[Docket No. **FAA-2025-2546**; Project Identifier **AD-2025-01060-T**; Amendment **39-23414**; AD 2026-15-02]

Airworthiness Directives; The Boeing Company Airplanes

ACTION: Final rule.

Figure 1 to paragraph (i) – 28-AWL-05

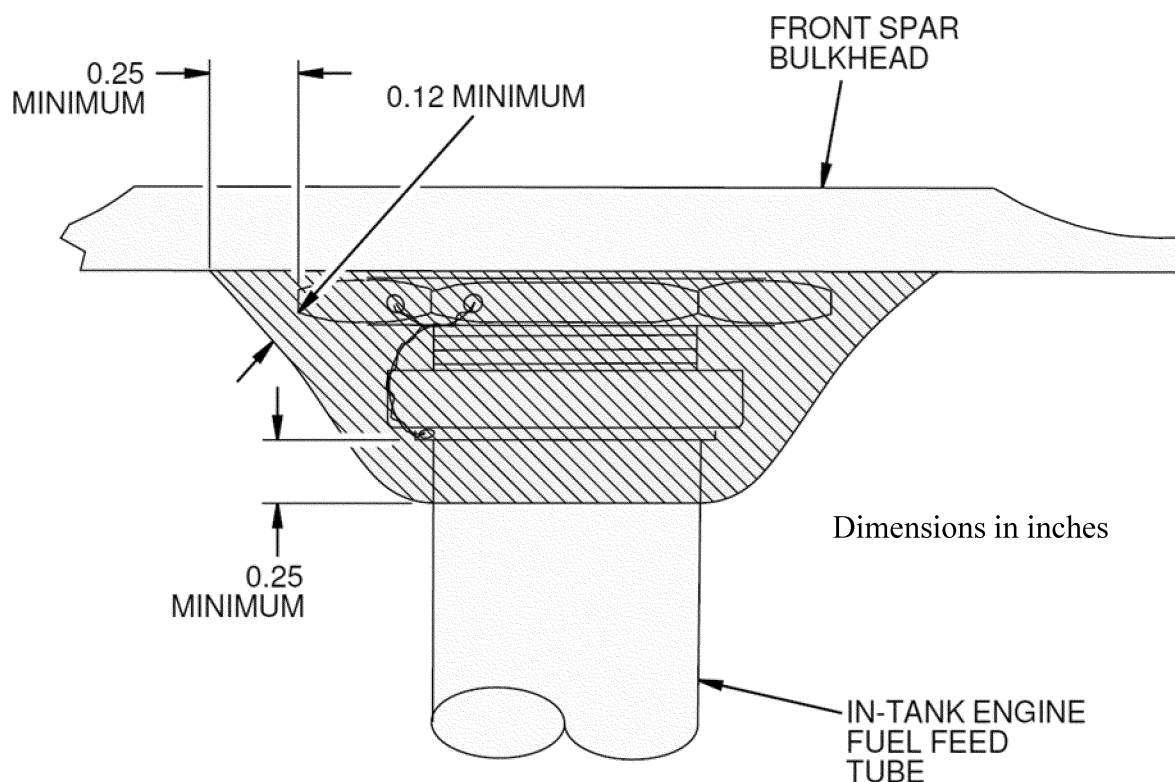
Boeing requested that the FAA revise figure 1 to paragraph (i) of the proposed AD to replace the reference to "Service Bulletin 777-28A0098" with Aircraft Maintenance Manual (AMM) 28-22-15/201 Temporary Revision, published between September 16, 2025, and September 17, 2025, or AMM 28-22-15/201 published on or after January 5, 2026, for the encapsulation procedure within the AWL. Boeing noted that standard practice is to reference AMM tasks in the description section of an AWL rather than a service bulletin.

The FAA agrees and has revised figure 1 to paragraph (i) of this AD accordingly.
